# HISTORIC AND DESIGN REVIEW COMMISSION

**HDRC CASE NO:** 2022-056  
**ADDRESS:** 555 S ALAMO ST  
**LEGAL DESCRIPTION:** NCB 901 BLK LOT 44, 45 & 46  
**ZONING:** D, H, RIO-3  
**CITY COUNCIL DIST.:** 1  
**DISTRICT:** La Villita Historic District  
**APPLICANT:** James McKnight/Brown & Ortiz, PC  
**OWNER:** Eric Stone/AUTO HOTEL LLC  
**TYPE OF WORK:** Construction of a fitness center, construction of accessory structures, site modifications,  
**APPLICATION RECEIVED:** January 14, 2022  
**60-DAY REVIEW:** Not applicable due to City Council Emergency Orders  
**CASE MANAGER:** Edward Hall

**Historic and Design Review Commission**  
***Design Review Committee Report***

04 BAR SECTION SOUTH - NORTH  
3/8" = 1'-0"

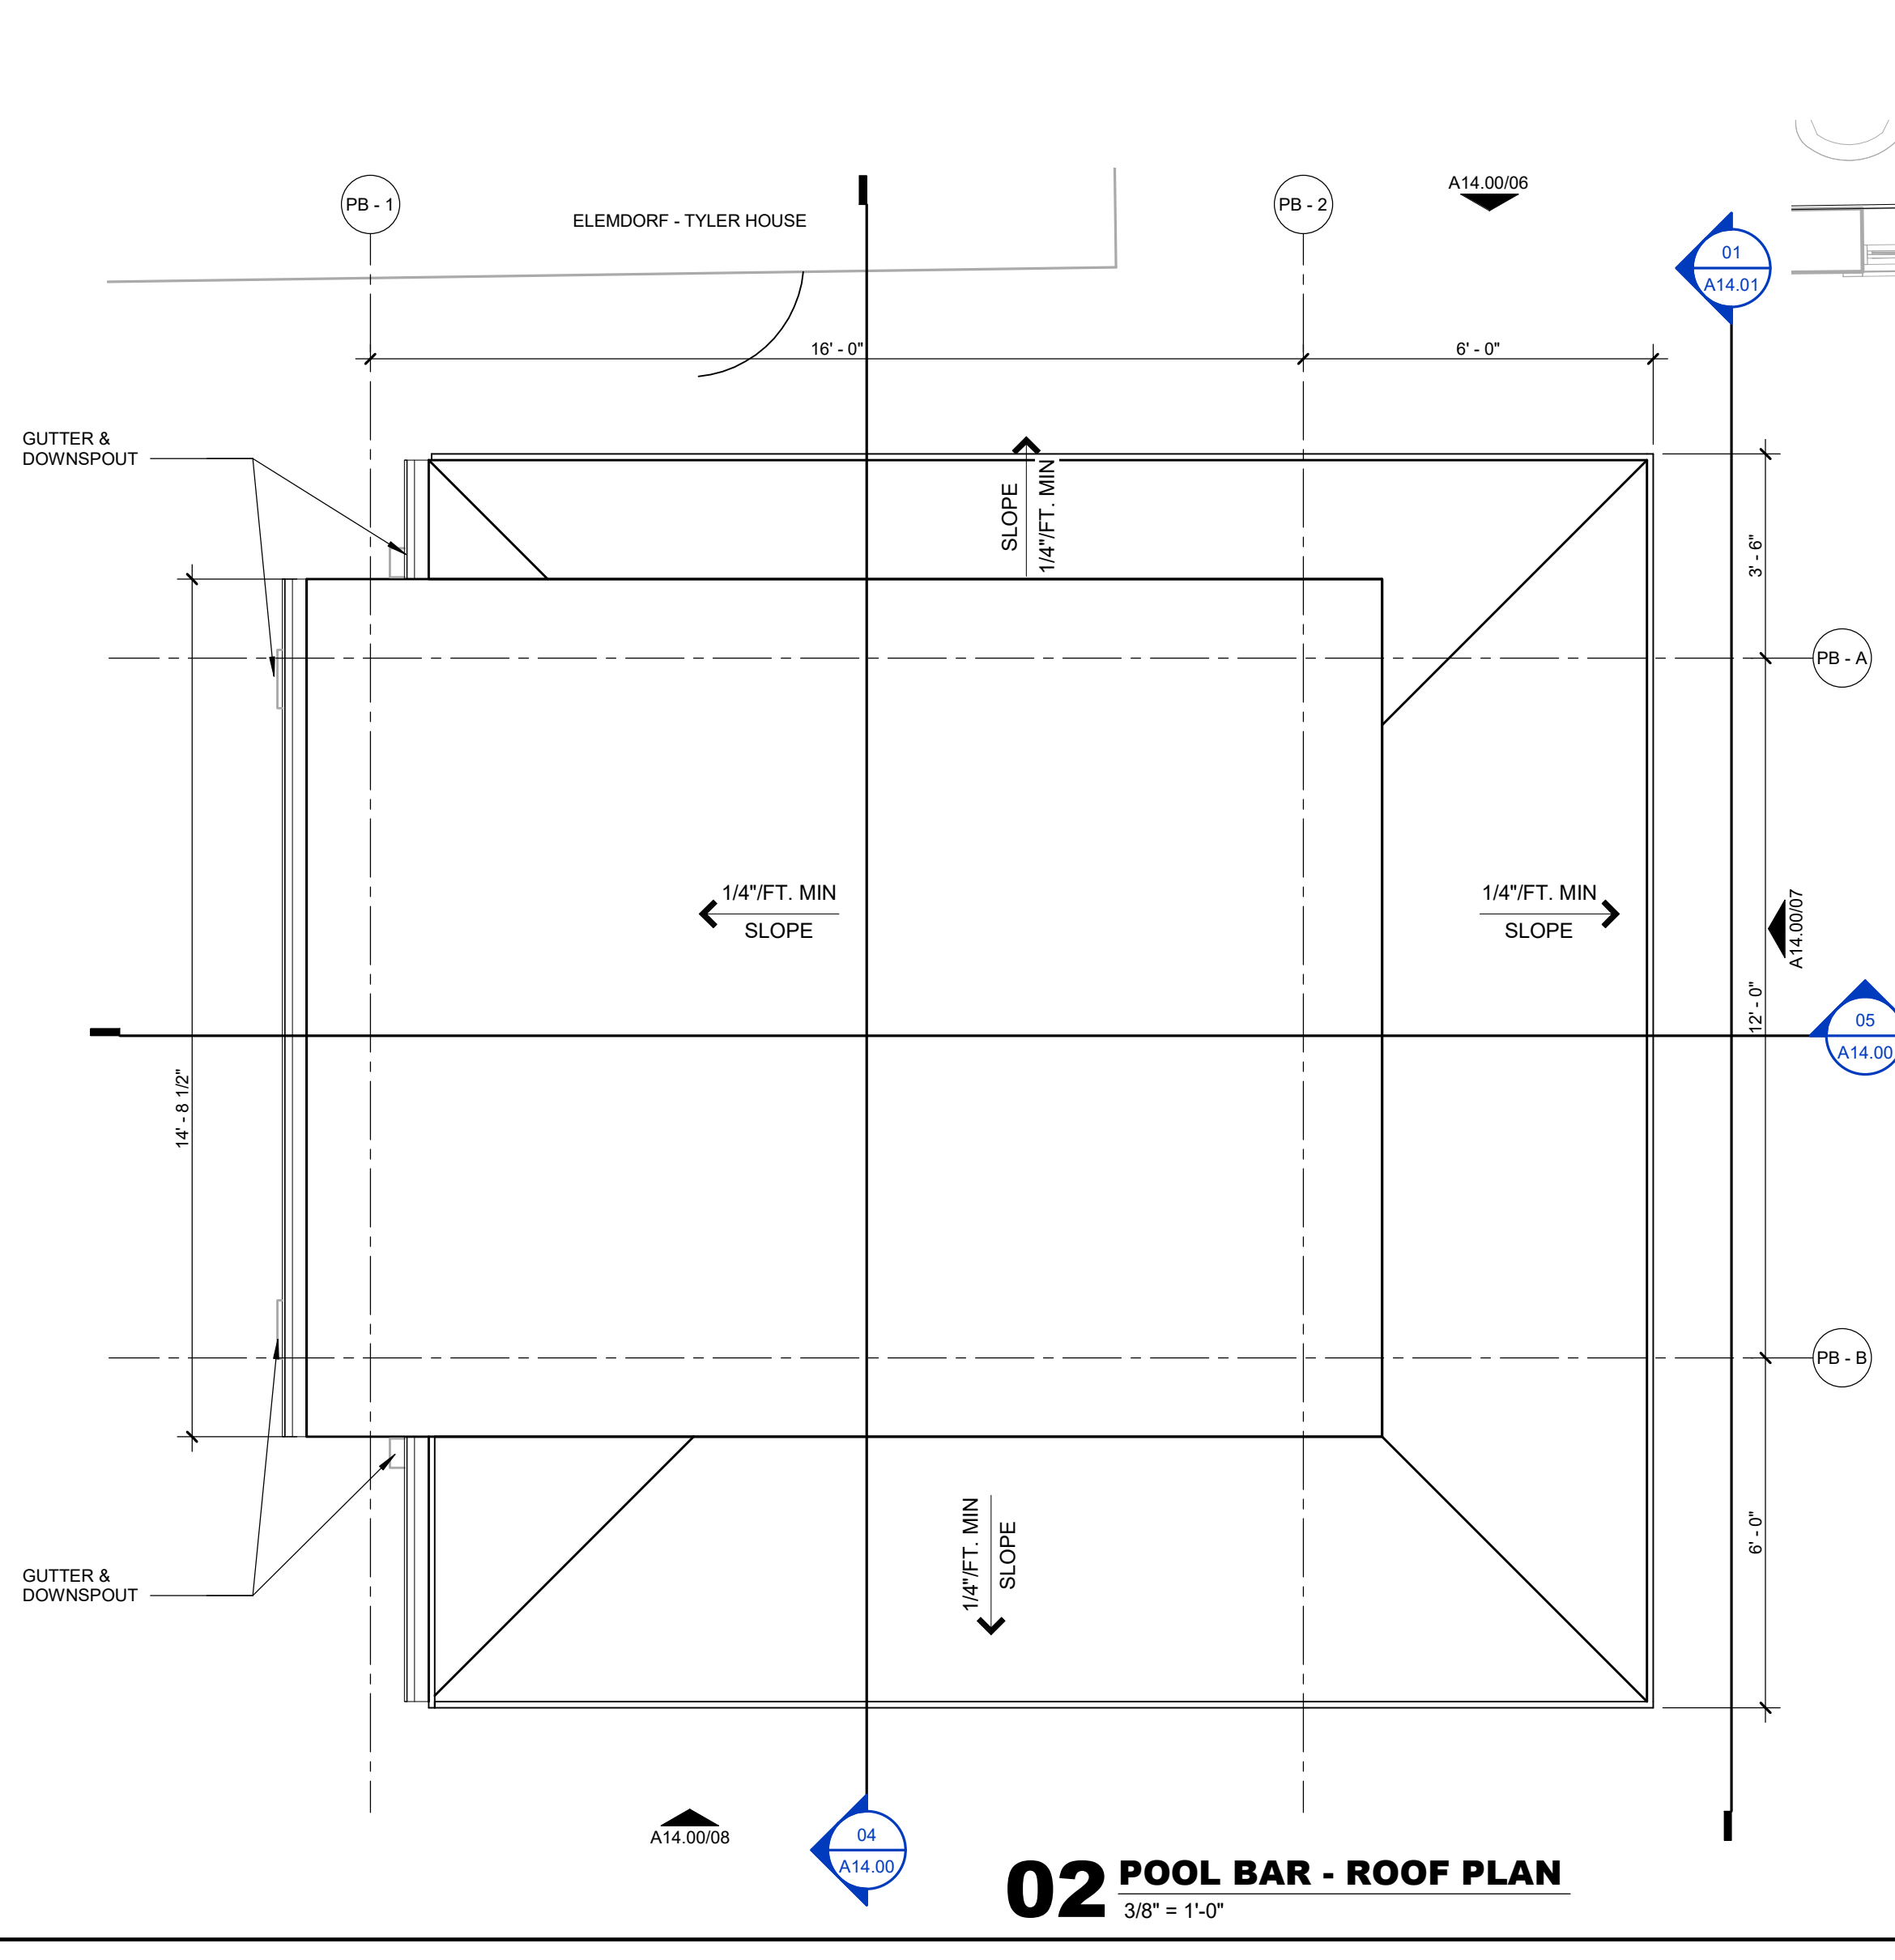
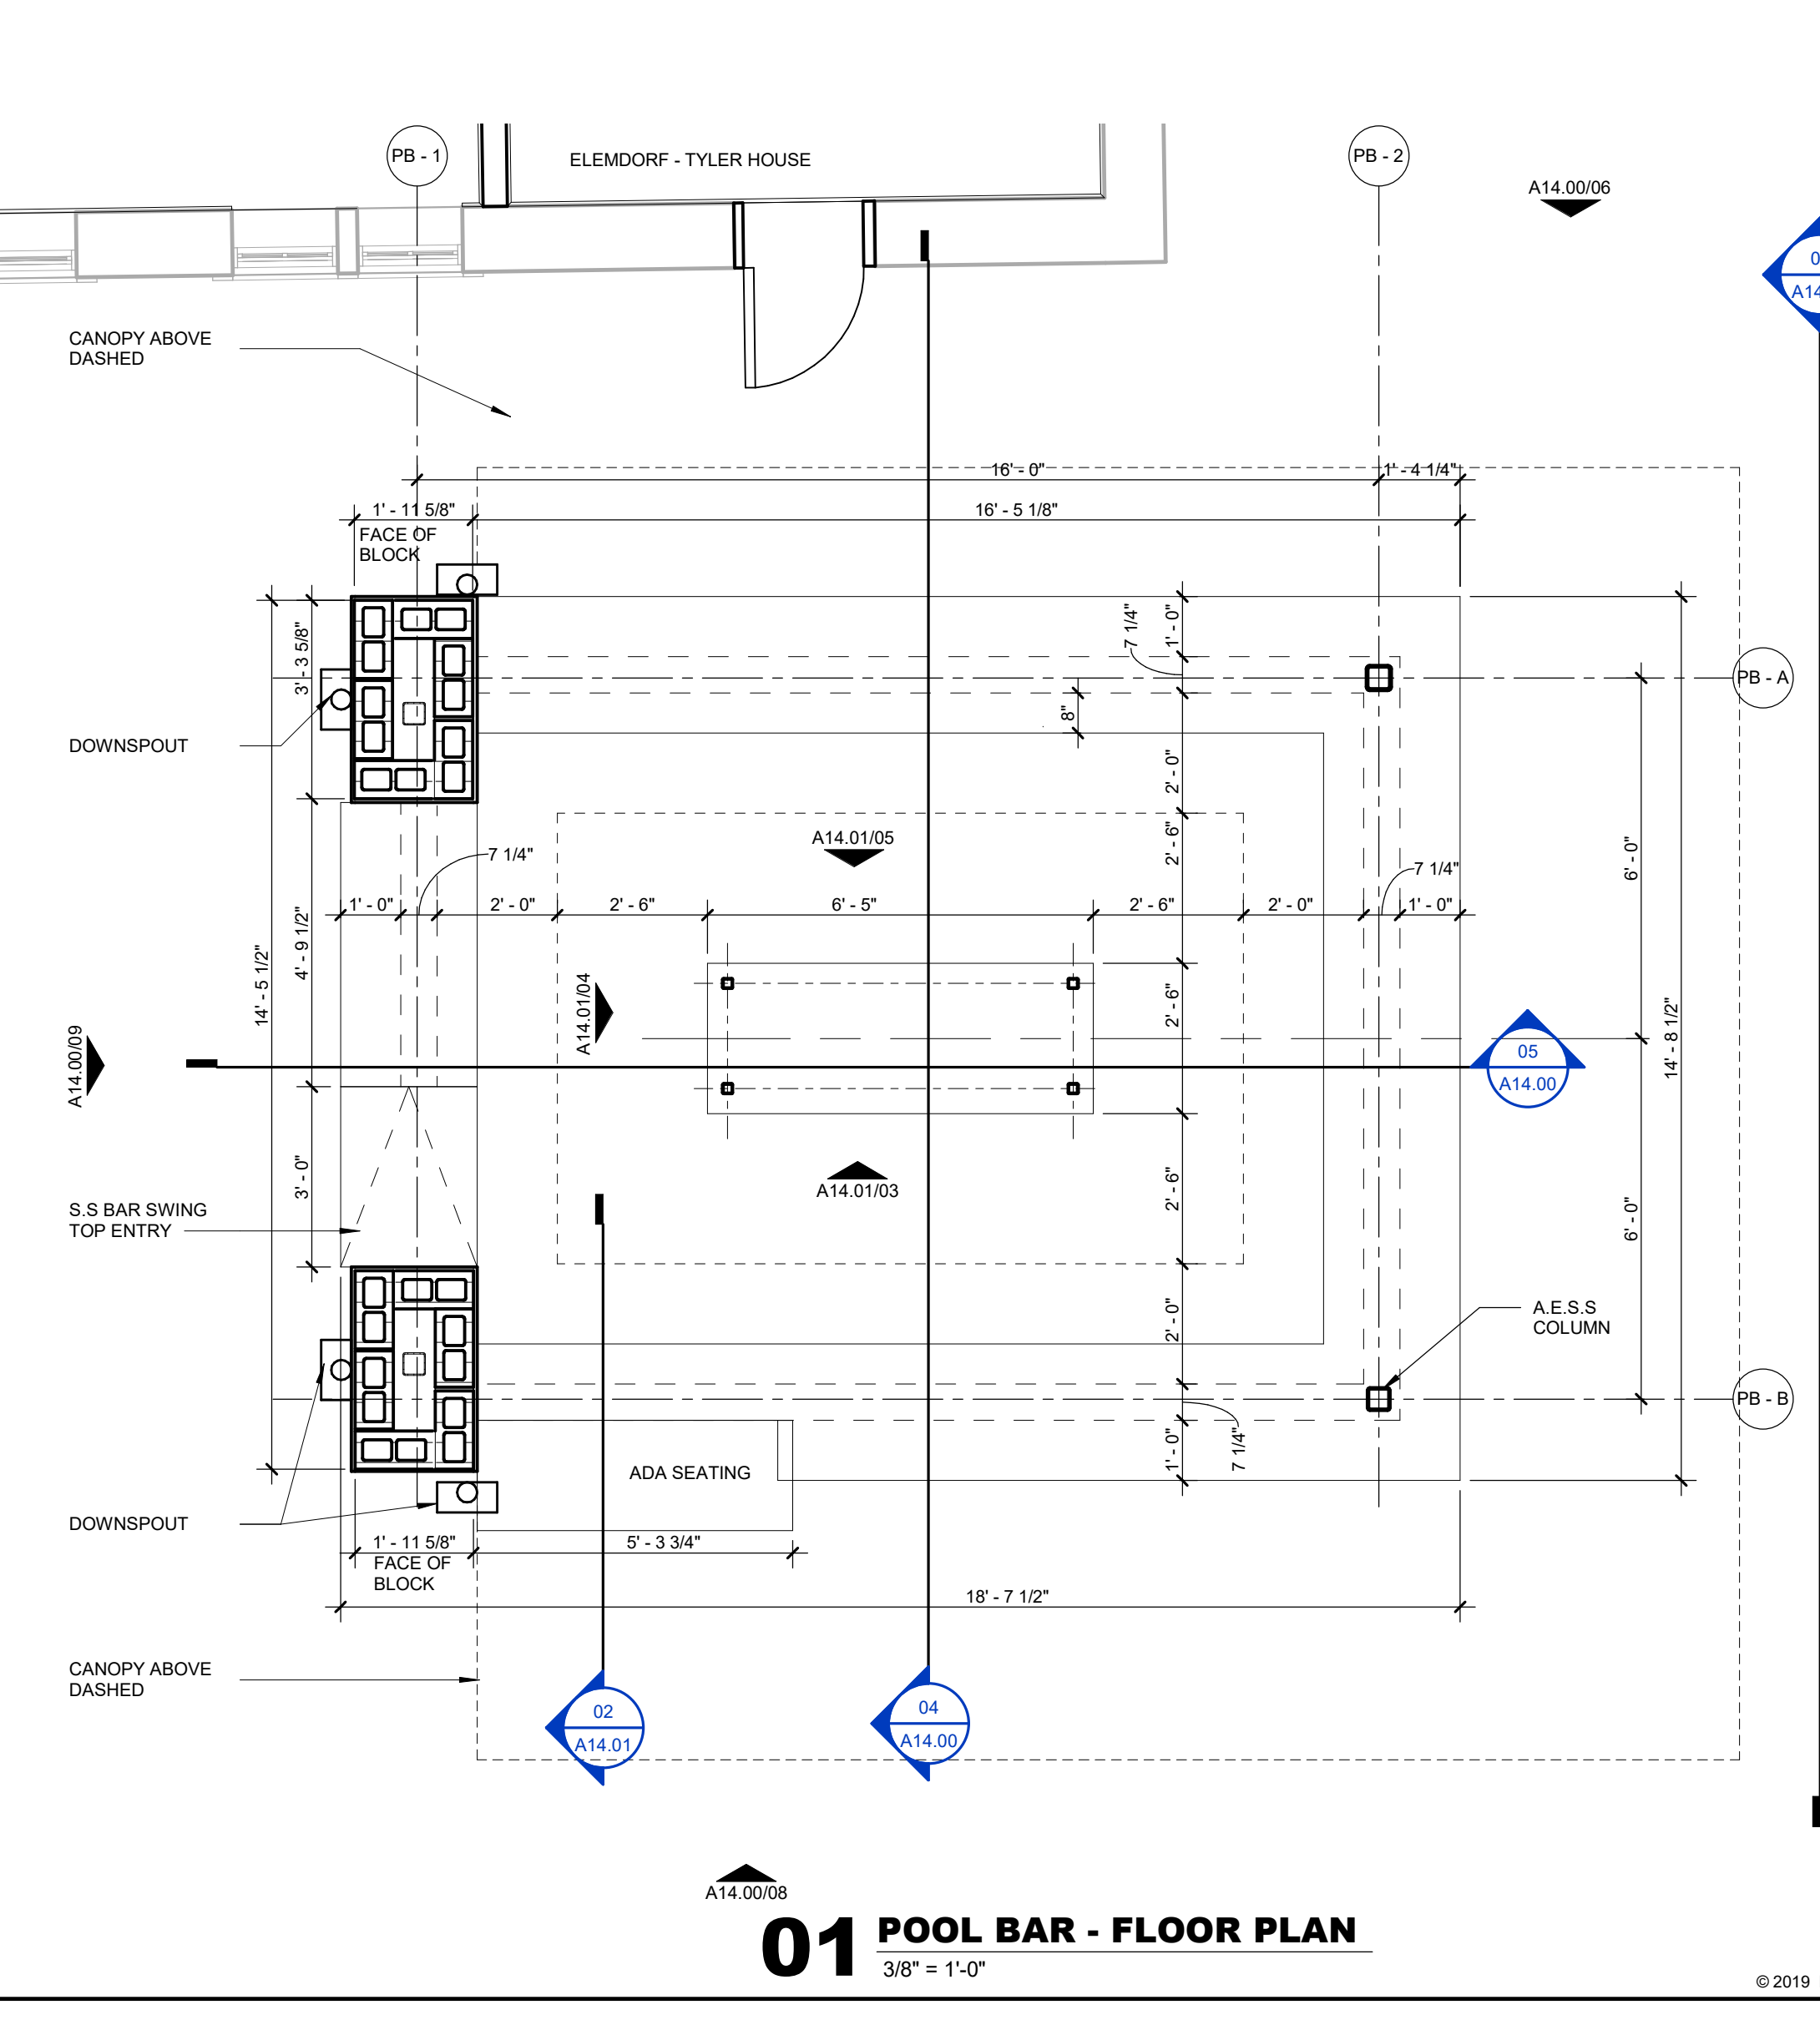
GV: Concerned about the proximity of the roof structure of the pool pavilion to the adjacent historic structure. Does not find the roof plane to be the correct solution.

JF: Study the roof form and the relationship between the north side of the roof in relationship to the historic building – not as much overhang will be needed on the north side.
